Local Planning Panel

Agenda

- 1. Disclosures of Interest**
- 2. Confirmation of Minutes**
- 3. Development Application: 50-58 Sir John Young Crescent, Woolloomooloo - D/2026/38**
- 4. Development Application: 51 Buckingham Street, Surry Hills - D/2026/64**
- 5. Development Application: 86-90 Bay Street, Ultimo - D/2026/136**
- 6. Report to the Local Planning Panel - Status of Applications**

Figure 13: Proposed plan - roof terrace

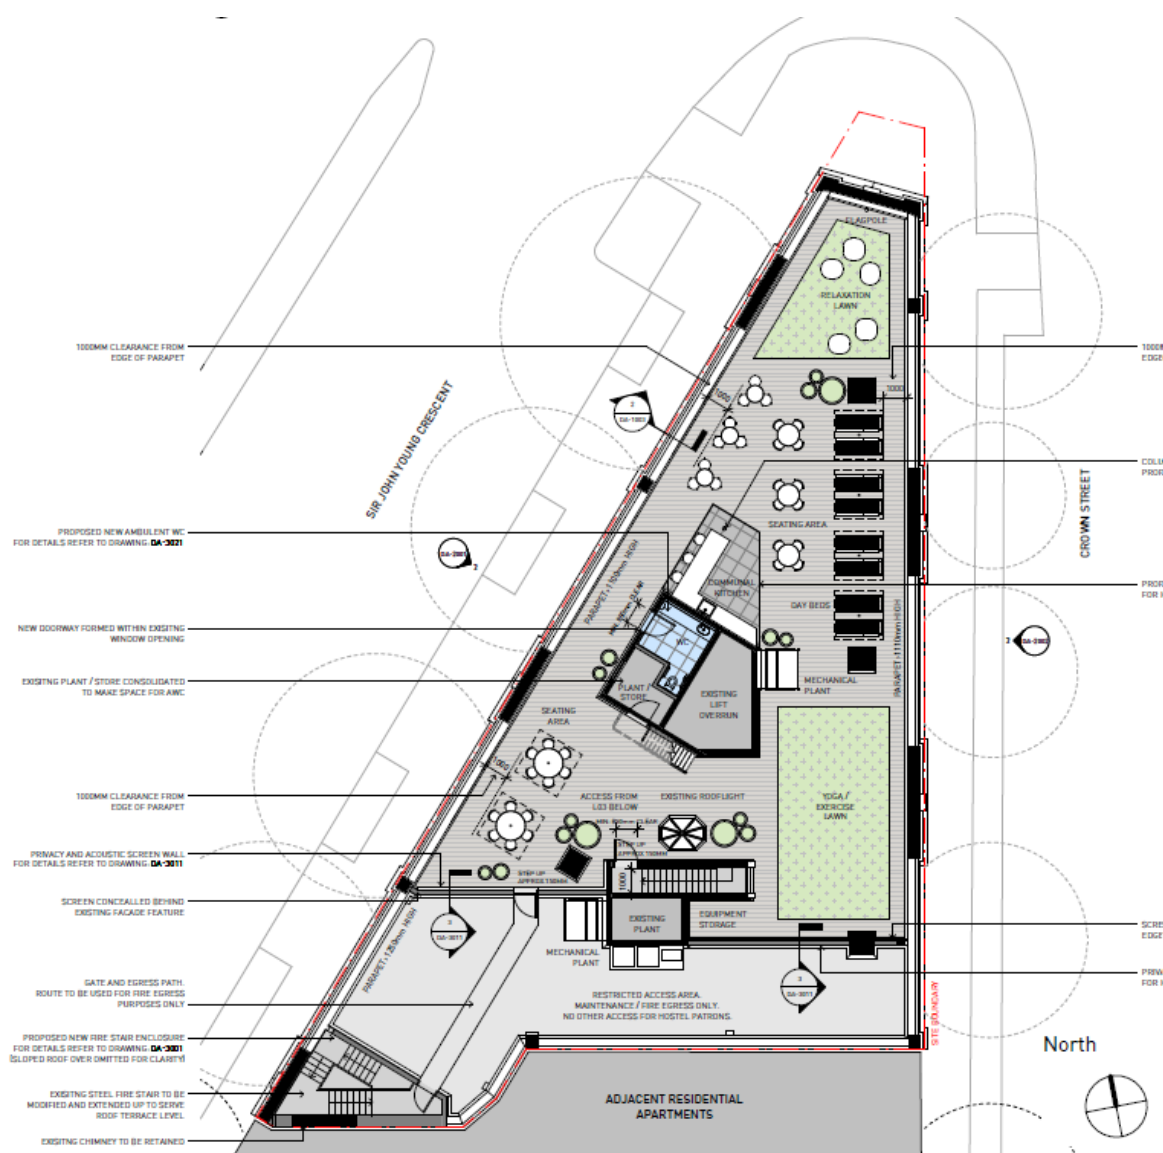
20. However, as demonstrated in Figure 22 below, both the proposed fixed umbrellas and the proposed canopy above the kitchen area exceed the 18-metre height limit under the Sydney LEP 2012. These structures are not excluded from the LEP definition of 'building height' and therefore must be included in the height calculation. The fixed umbrellas reach a maximum height of 18.8 metres (a 4.4% exceedance), while the canopy reaches 18.5 metres (a 2.7% exceedance).
